El Camino Memorial Park  
2<sup>nd</sup> Response to Development Service Department  
Project No. GS 16B12  
August 30, 2021

**SUBJECT:** El Camino Memorial Park Secret Canyon Expansion, 2<sup>nd</sup> Response to the City of San Diego Development Services Department # 670391-2 dated October 21, 2020, page 14, and # 0670391-4 dated June 11, 2021, located at 5600 Carroll Canyon Road San Diego, California 92121.

SUBJECT: El Camino Memorial Park Secret Canyon Expansion Area Storm Water Quality- Infiltration Feasibility Condition Letter, located at 5600 Carroll Canyon Road San Diego, California 92121.

**Exhibit: Infiltration Feasibility Condition Letter (C.1.1)**

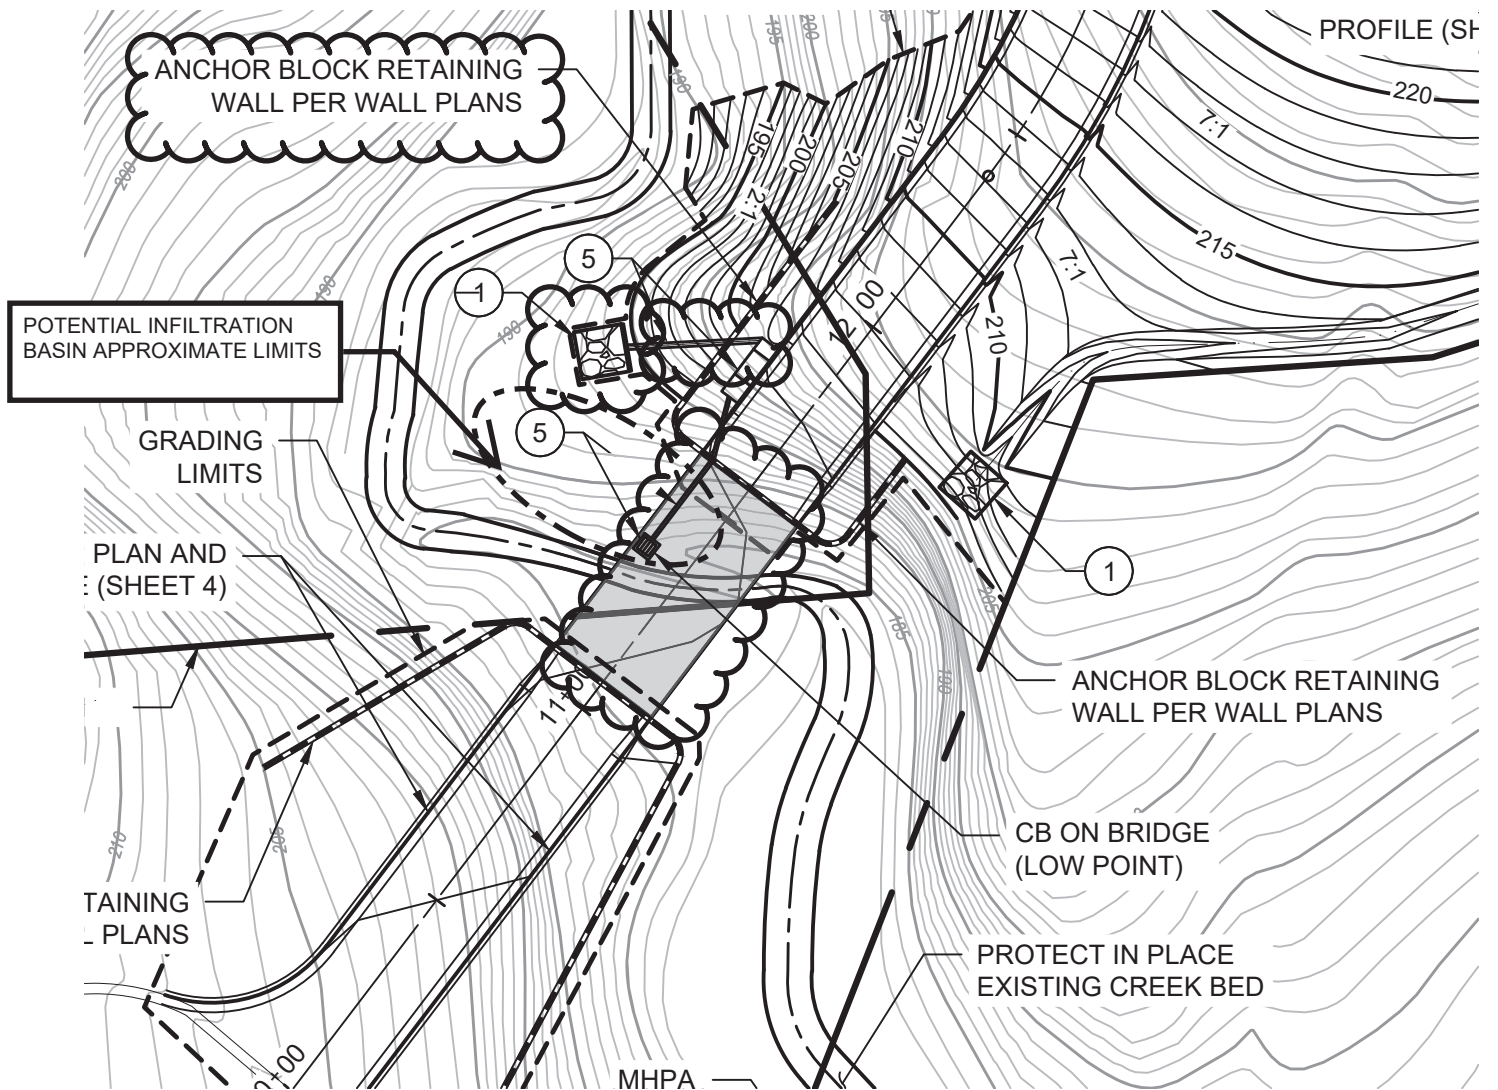
This letter is to provide justification for a “No Infiltration Basis” finding for the referenced project. The 2018 SWQ Manual, Appendix C, Section C.1 and C.1.1 sets requirements for “No Infiltration” basis justification. Included are required minimum setbacks from structures of 10-feet for infiltration. The below project elements would not meet this requirement:

- 1) The proposed bridge structure
- 2) Drain inlet foundations and structures
- 3) Roadways

Clouded project elements do not meet required 10 foot setback for infiltration
